# Service Technical Information

MODEL NO.	XR-MD85 EZ
SUBJECT	Tape stop at FM recording

REF.No. :G - 99 - 047 - E0

DATE :01. NOV. 1999

## MAIN C.B. PATTERN SIDE

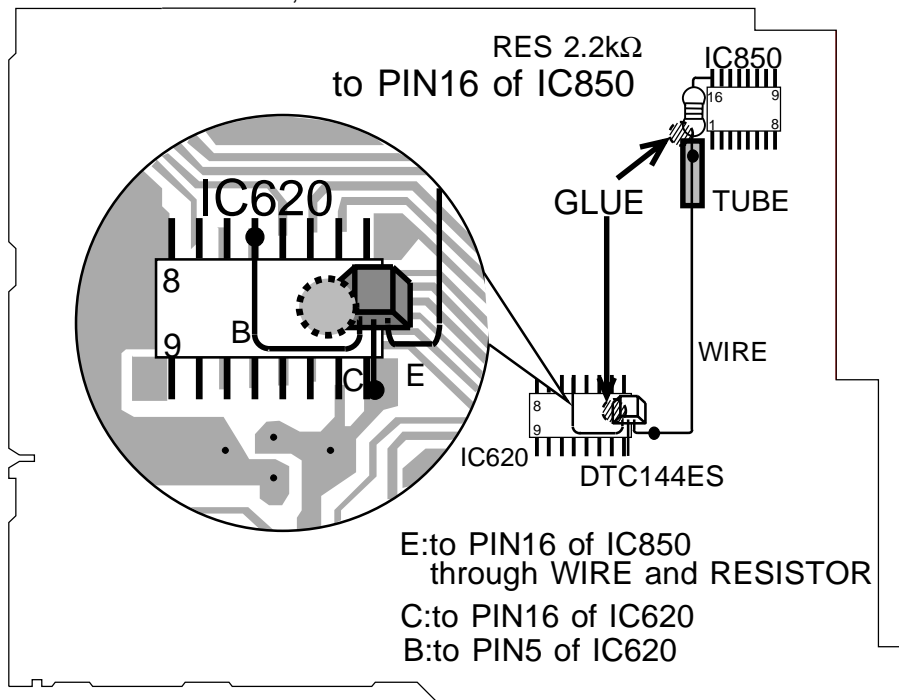
A tape stops in approximately 5 minutes after starting recording of an FM program on tape, using the model in question.

This problem occurs when an FM signal includes RDS signal.

Take the following steps:

1. Solder the base terminal of DTC144ES to pin 5 on IC620, and solder the collector terminal of DTC144ES to pin 16 of IC620.
2. Solder the emitter terminal of DTC 144ES to the wire, and let the wire in the tube.
3. Solder an end of the wire to the resistor.  
Solder the other end of the resistor to pin 16 of IC850.
4. Lock DTC144ES onto IC620, and lock the tube and the resistor onto the main C.B. with glue.

After taking the above actions, RDS indication will not be updated during REC operation on tape.
